Planning and Land Use Department Planning Commission Staff Report

Case #2025-10685. Tierra Contenta Preliminary Subdivision Plat. JenkinsGavin, Inc., Agent for Homewise, Inc., owner and applicant (“Applicant”), requests review and approval of a Preliminary Subdivision Plat for 16 development tracts and 6 open space tracts for a total of 22 tracts and Innovative Street Design. The subject lots are 216.5 acres and are located at 6120, 6130, 6150, and 6135 Paseo del Sol. The lots are zoned Planned Residential Community District (PRC) and lie within the Suburban Archaeological Review District. (Rebekah Clouser, Case Manager, reclouser@santafenm.gov).

Case #2025-10688. Tierra Contenta Preliminary Subdivision Plat Variance (Slopes). JenkinsGavin, Inc., Agent for Homewise, Inc., owner and applicant (“Applicant”), requests a variance from SFCC 14-8.2(D)(2)(b) Terrain Management standards prohibiting disturbances of natural slopes of thirty percent (30%) for an approximate area of 7,305 square feet. The subject lots are approximately 216.5 acres and located at 6120, 6130, 6150, and 6135 Paseo del Sol,

Figure 3: Innovative Street Design Paseo del Sol Arroyo Crossing to West Roundabout

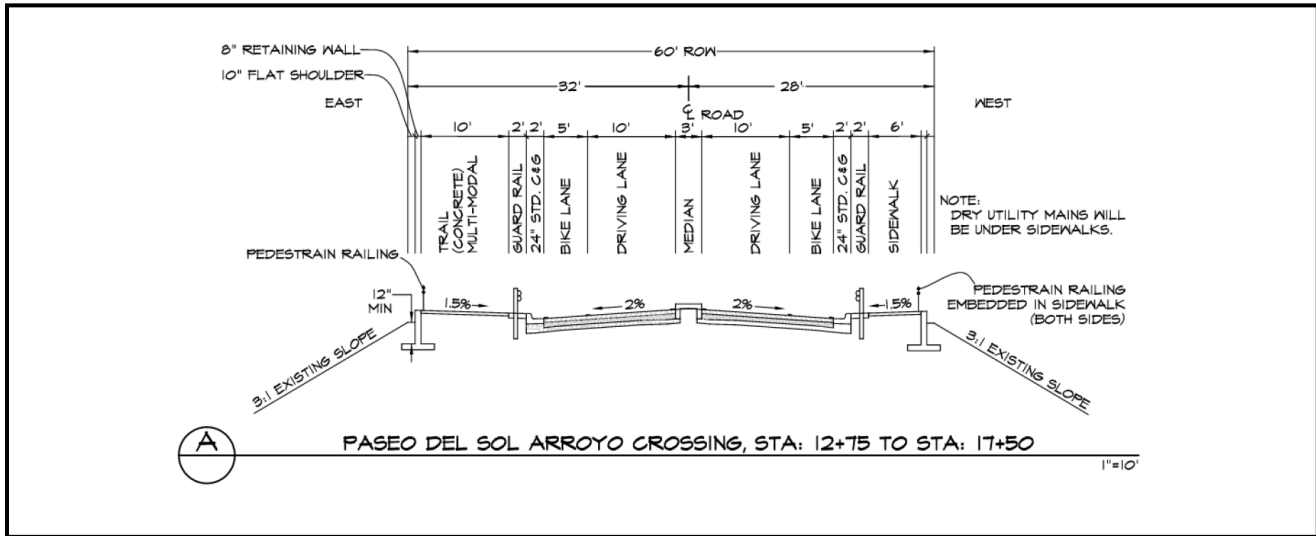
The first road section submitted for innovative design is Paseo del Sol Arroyo Crossing up to the West Roundabout. This road section is proposed over an existing sewer utility line and the Arroyo Chamiso. The proposed innovative design includes two drive lanes, two five-foot bike lanes, a three-foot concrete median with roll curbs, a six-foot sidewalk on one side and on the other side of the road a ten-foot multi-modal trail, see Figure 3: *Innovative Street Design Paseo del Sol Arroyo Crossing to West Roundabout*. As this road section is constrained by steep topography and the Arroyo Chamiso, staff recommends approval of the proposed innovative

street design because it addresses the constraints and accommodates all modes of transportation.

Figure 4: Innovative Street Design Arroyo Crossing Transition

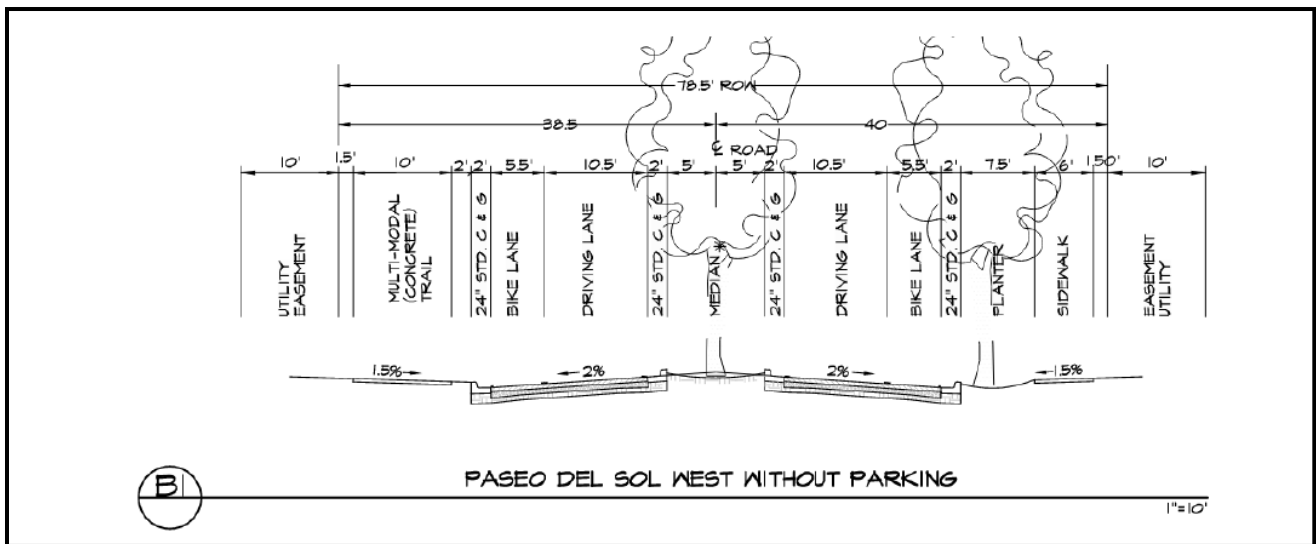
The second road section proposed for an innovative street design is Paseo del Sol West without parking from the arroyo crossing transition. The proposed innovative street design includes two drive lanes, a ten-foot planter strip median, two five-foot bike lanes, sidewalk on one side with a 7.5-foot planter strip and continues the multi-modal trail from the first proposed road section and provides a transition from the narrower road section to the wider road sections to the east. See Figure 4: *Innovative Street Design Arroyo Crossing Transition*. Staff recommends approval of the proposed innovative street design.

Figure 5: Innovative Street Design Paseo del Sol Through NMSD

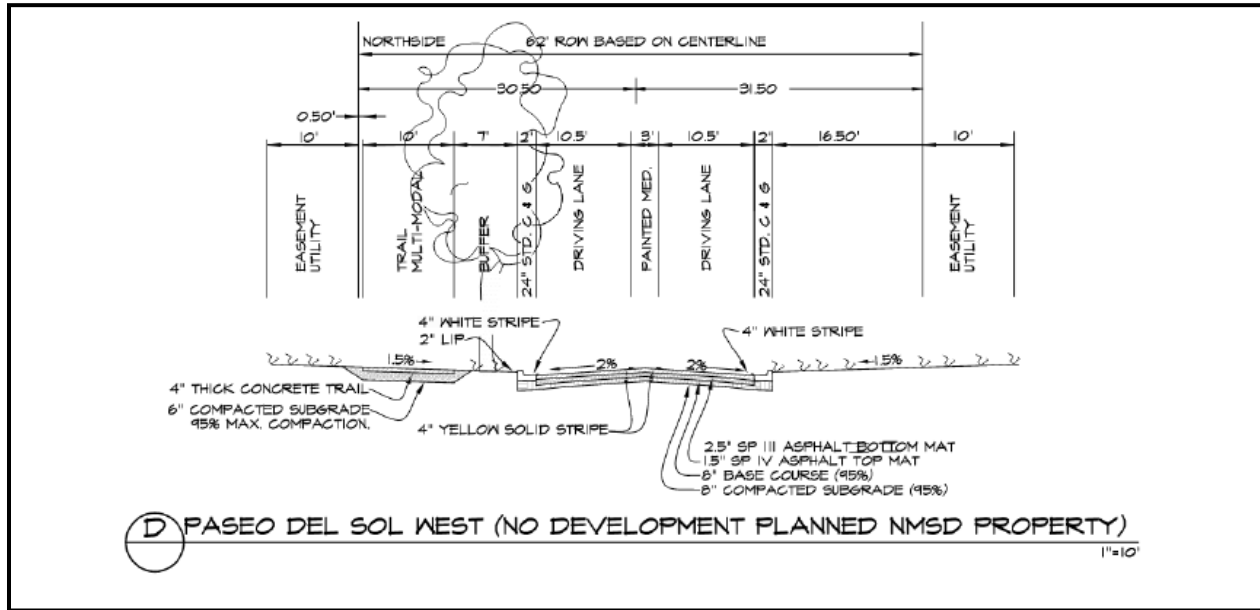
The last request for an innovative street design is Paseo del Sol through the New Mexico School for the Deaf property that connects Phase 3 to Herrera Drive on the west. In an effort to mitigate vehicular traffic speeding through this section of Paseo del Sol, bike lanes were removed from the driving lanes, reducing the width of the driving lanes to 10'5". A 10-foot concrete multi-modal trail is proposed on the north side of the road to safely accommodate both pedestrian and bicycle users. Street trees will be planted in the seven-foot buffer along the northside between the road and the multi-modal trail. See Figure 5: *Innovative Street Design Paseo del Sol Through NMSD*.
